NAPA 6907 Air Filter Product Update

A recent update has taken place for the 6907 with a notable change in the sealing design.

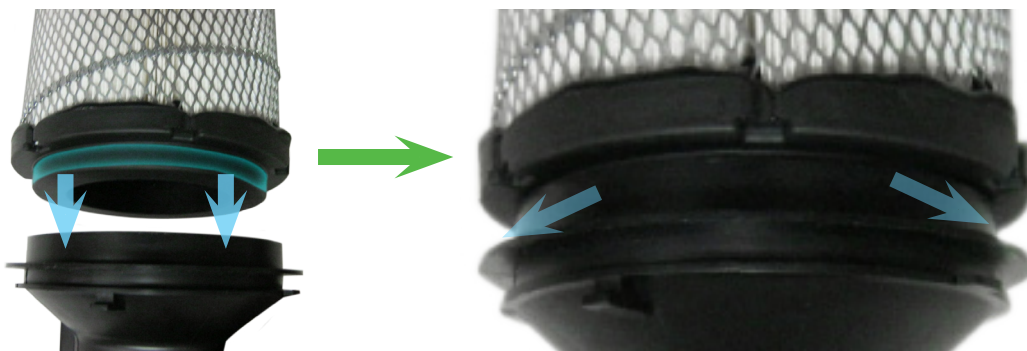
The previous seal is similar to the original equipment service (OES) that seals over the outside of the flow tube.

The updated design seals into the inside of the flow tube. The updated seal is more robust and easier to install/remove.

The update is part of an ongoing change. Principal applications included in this update are Chevrolet/GMC C4500 and C5500 trucks. It should be noted that both the previous and new 6907 are fully interchangeable and suitable for use on all recommended applications.
